**ADDENDUM NUMBER 4
Project Number: ESU 30-1436**

Issue Date: 5 August 2014

Project Title: Replace Chiller, Koehler Fieldhouse and Natatorium

1 MECHANICAL ROOM DEMOLITION PLAN
 MD-100 1/4"=1'-0"

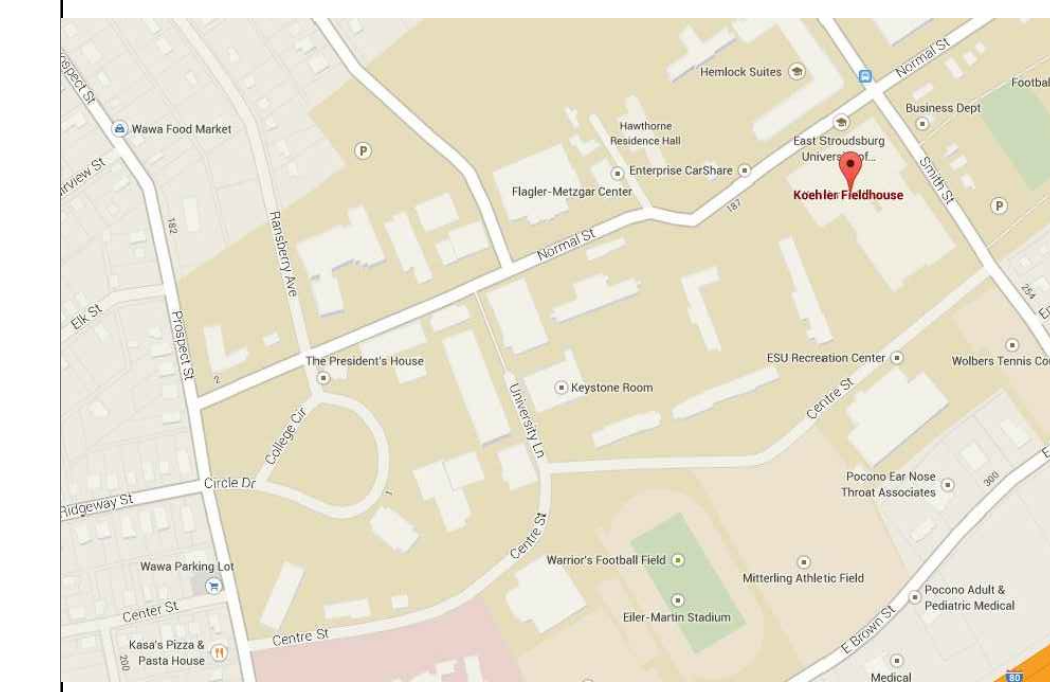
Revised Drawing 1/HD-100: Relocated the existing piping to reflect existing conditions. The piping is still to be considered diagrammatic. Removed existing pipe insulation of the six heating and dual temperature piping down to 12" above finished floor. Added note "Replace 3"x3"x1/4" steel bracket with new 3"x3"x1/4" stainless steel bracket. Added note "(E) Pump pad to remain for reuse (Typ. for each pump)."
General Notes: Added Note No. 2: Existing wall openings from pipe penetrations to be filled and sealed with matching brick and mortar."
General Demolition Note No. 9: Revised to read "The contractor shall leave all-thread hanger rods attached to the ceiling above the vibration isolators. All clevis hangers shall

be removed. Remove all vibration isolators, all-thread between isolators and clevis hangers from all pipes being removed from project.”

1 MECHANICAL ROOM LAYOUT
H-100 1/4"=1'-0"

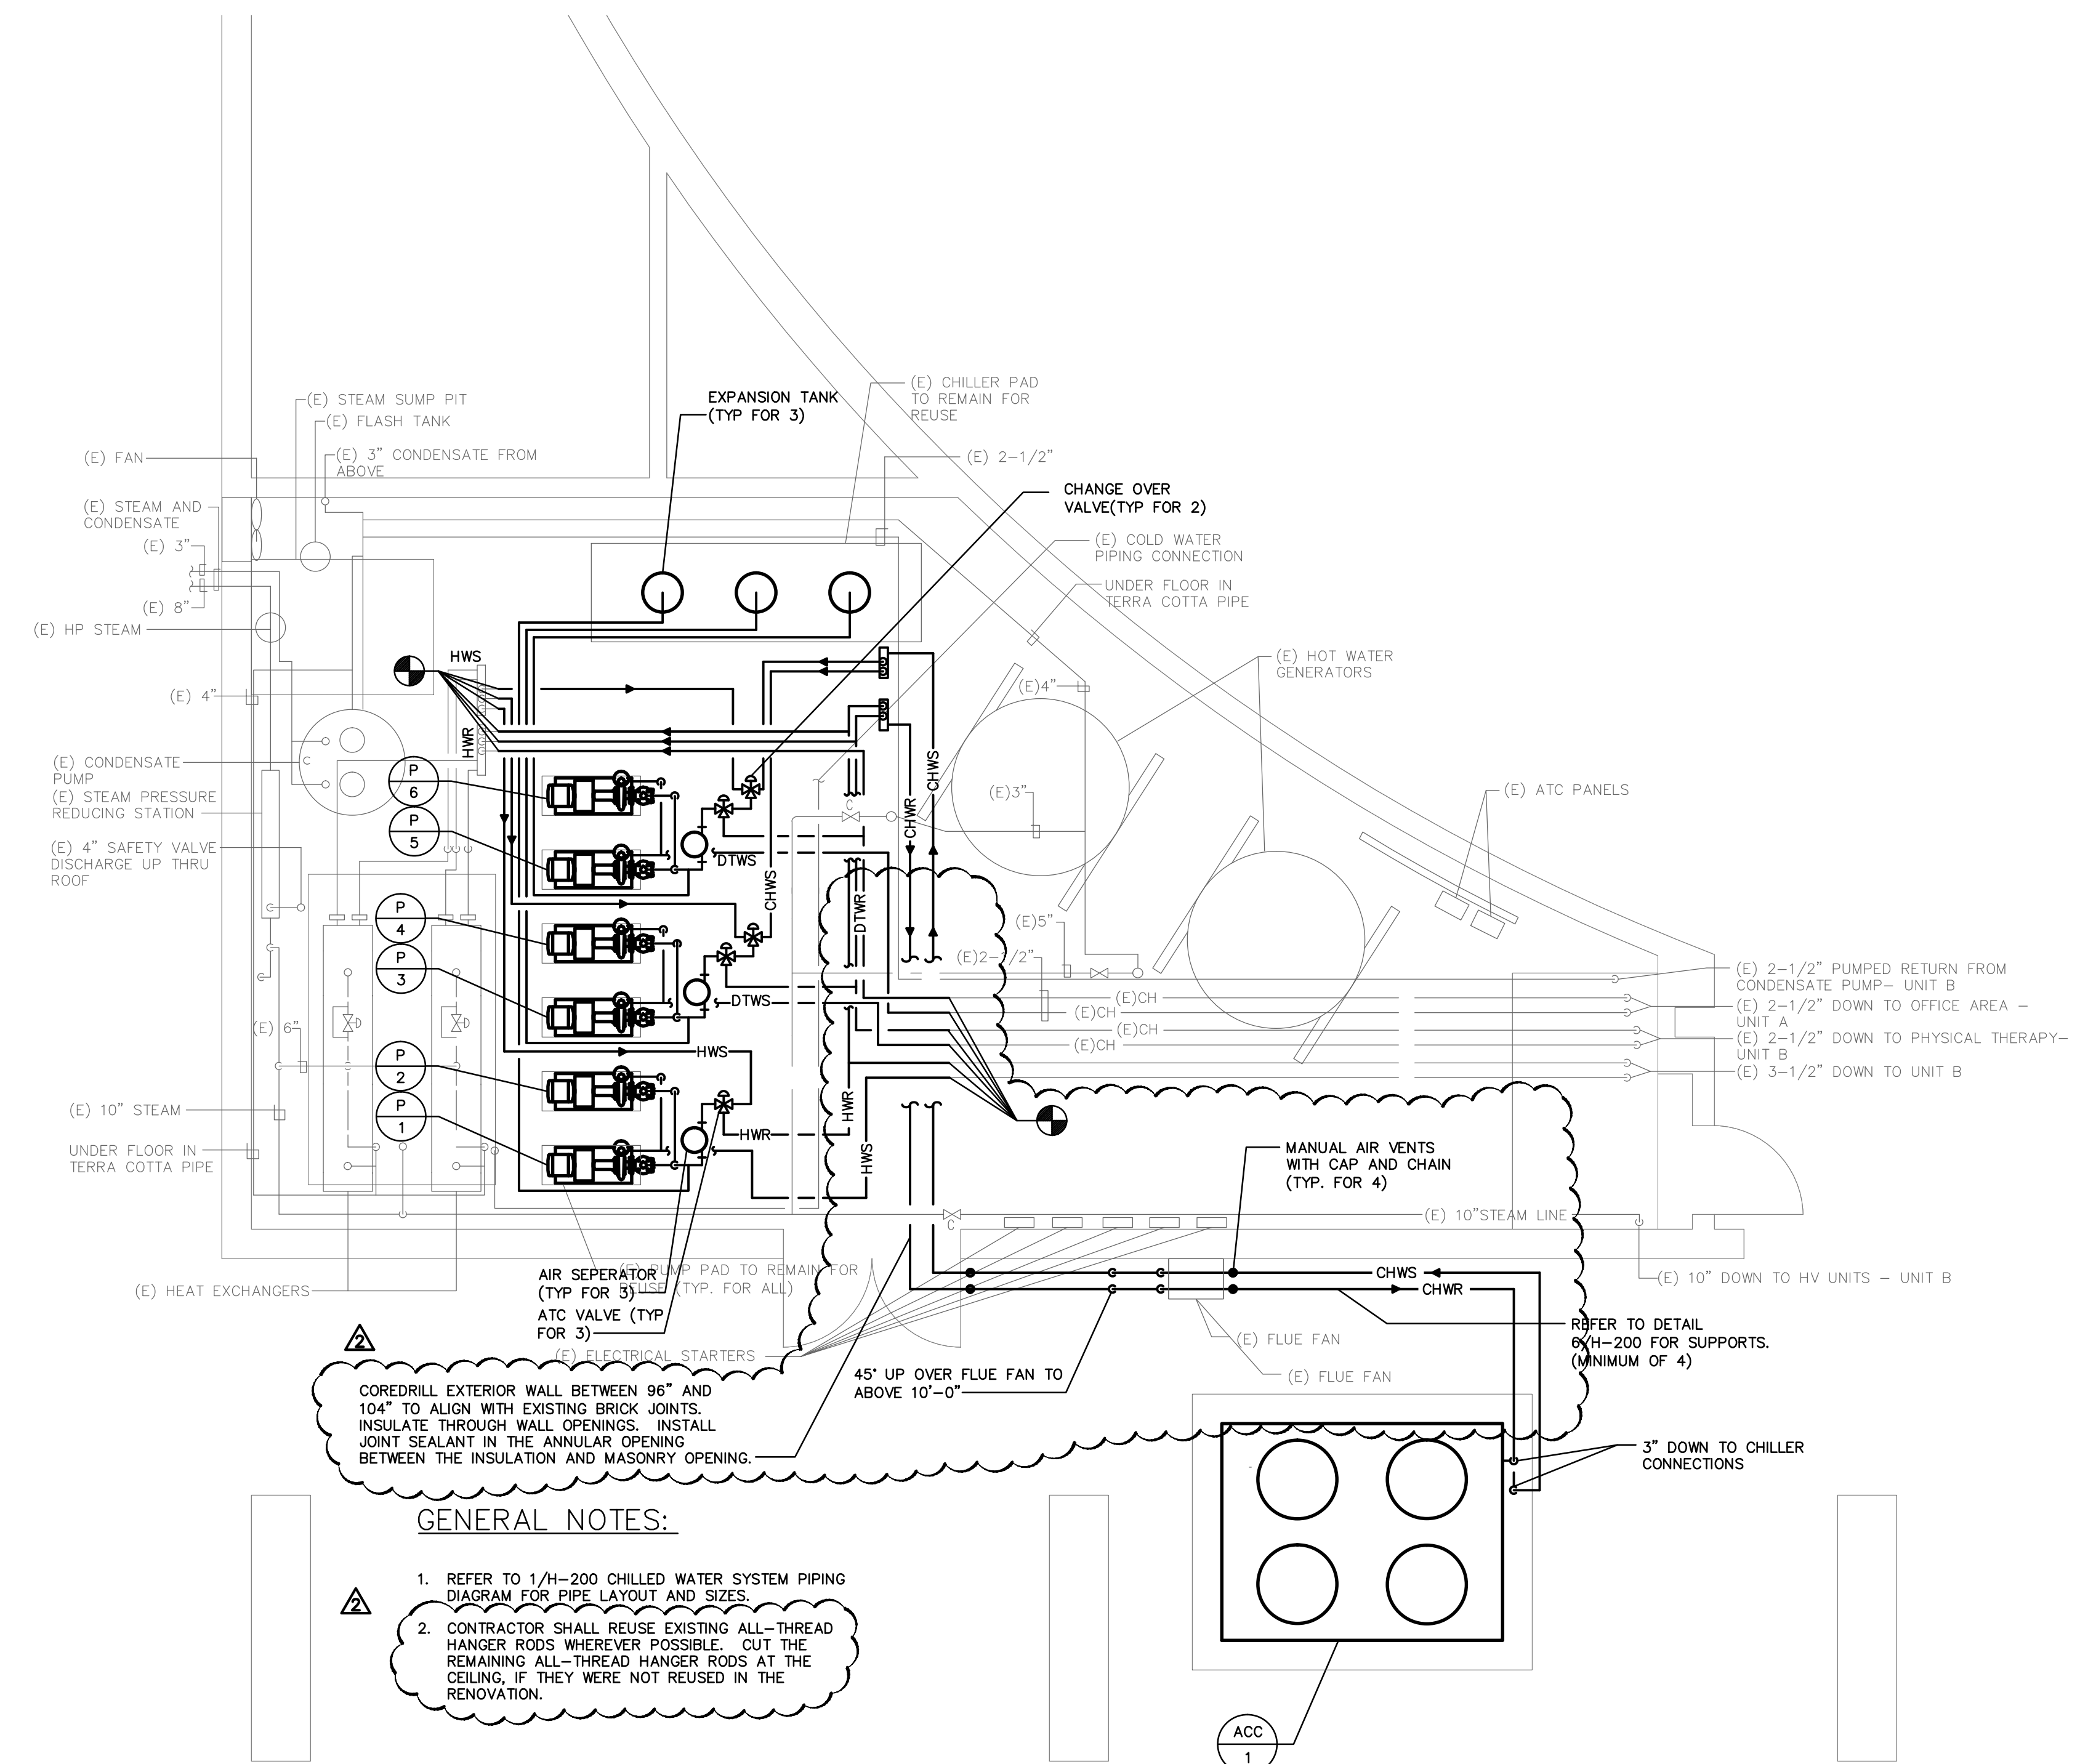
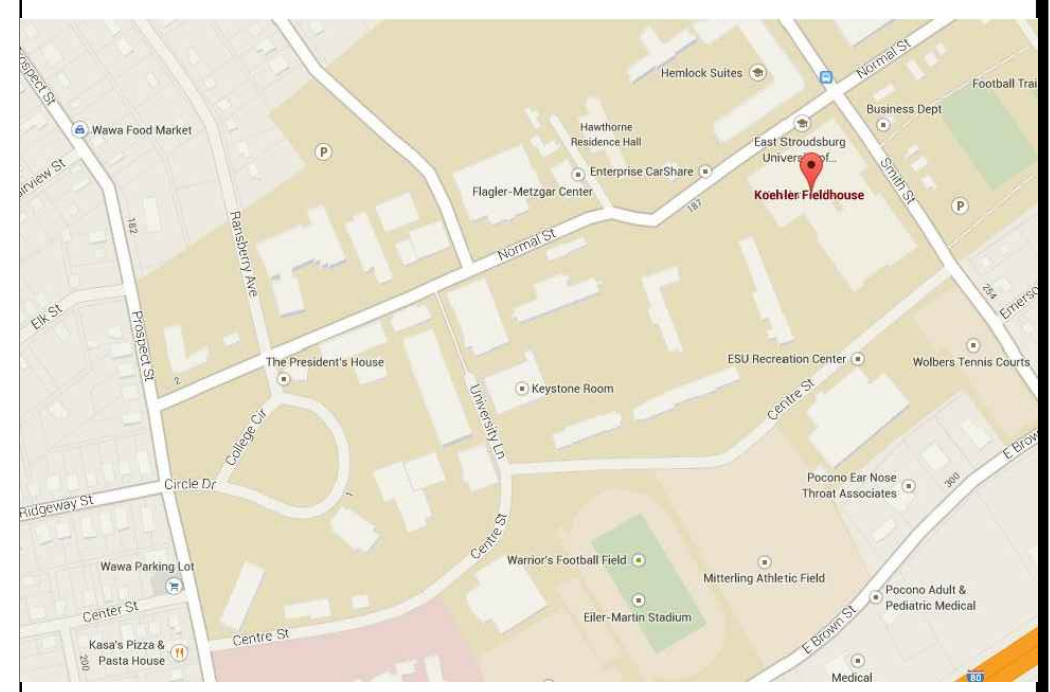
Revised Drawing 1/H-100: Relocated the chilled water piping from existing exterior wall opening to through the exterior wall above the door opening.

General Notes: Added “2: Contractor shall reuse existing all-thread hanger rods wherever possible. Cut the remaining all-thread hanger rods at the ceiling, if they were not used in the renovation.

1 CHILLED WATER SYSTEM PIPING DIAGRAM
SCALE: NONE

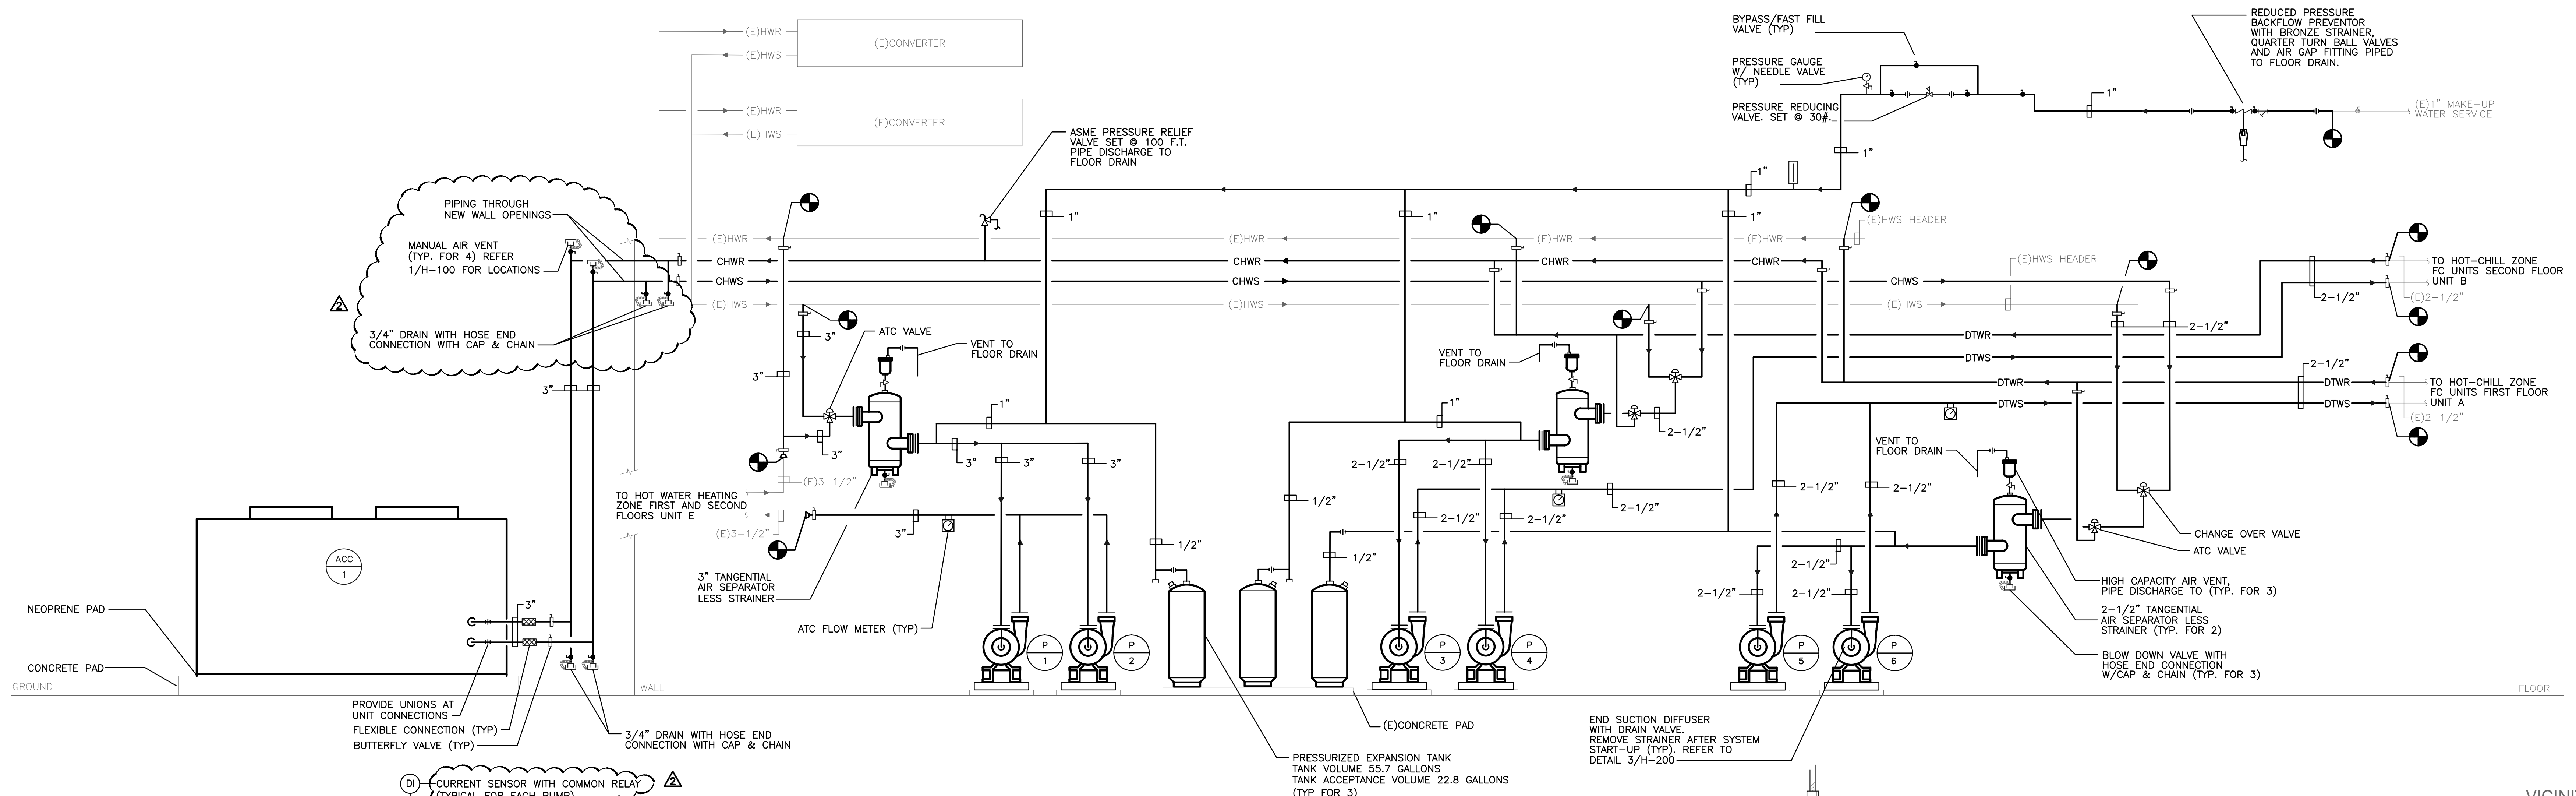
Diagram 1/H-200: Added “¾” Drain with hose and end connection with cap & chain” and revised the “Pipe Through Existing Wall Sleeves” to read “Pipe Through New Wall Openings.”

2 WATER SYSTEM CONTROL DIAGRAM
SCALE: NONE

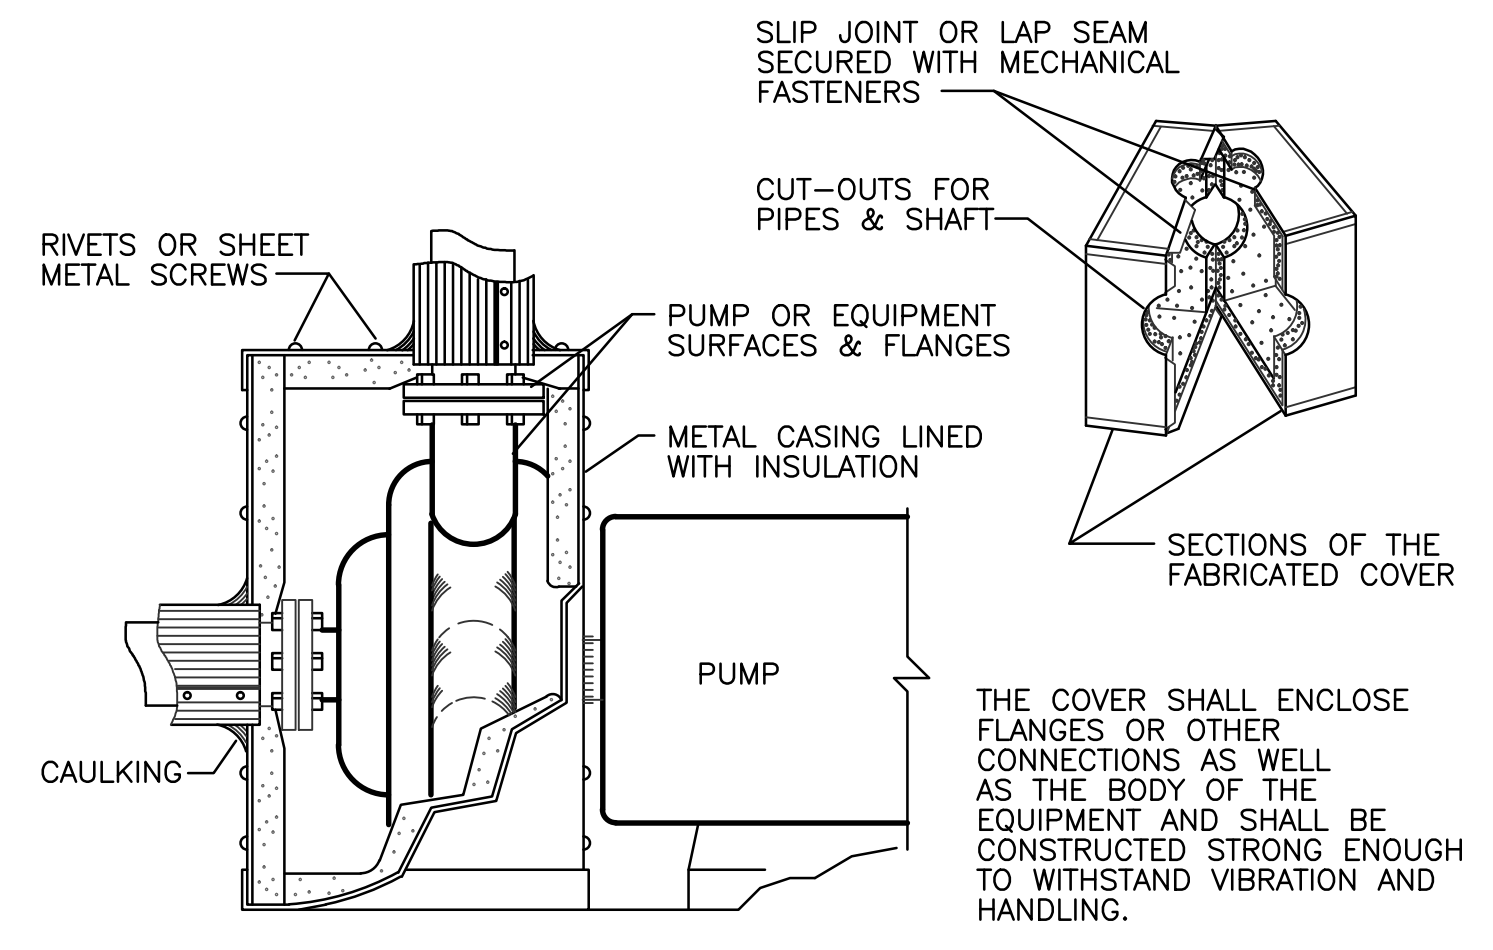
Diagram 2/H-200: Revised word in top note from “rely” to “relay”

6 EXTERIOR PIPE SUPPORTS
SCALE: NONE

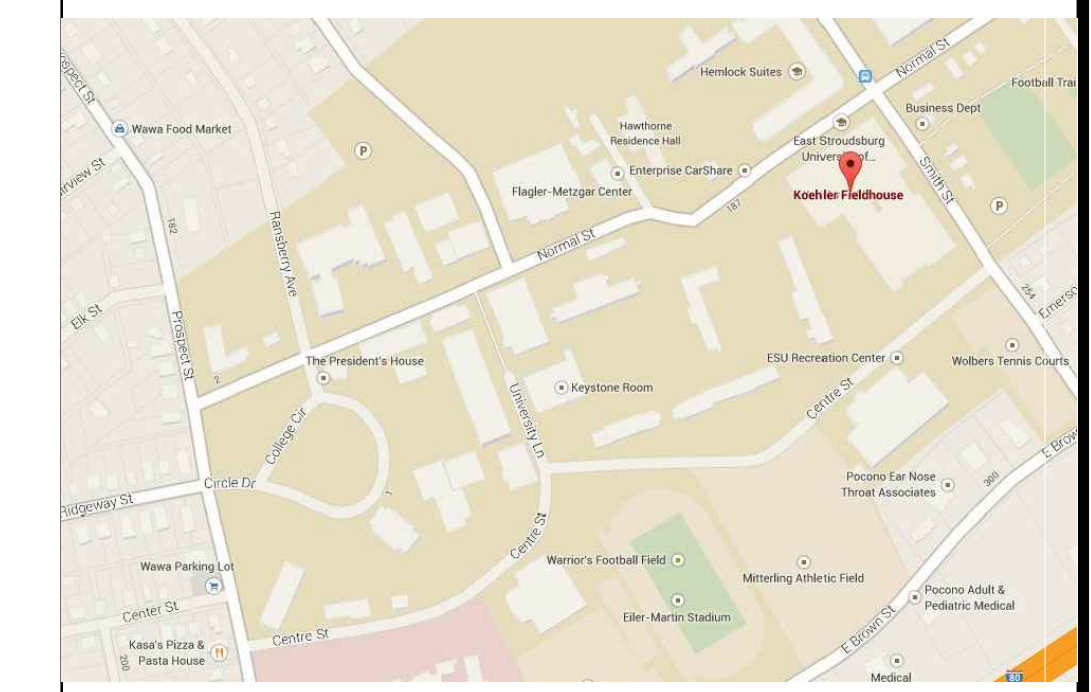
Added Detail 6/H-200 Exterior Pipe Supports. Rearranged Details 2/H-200 through 5/H-200 with no changes.
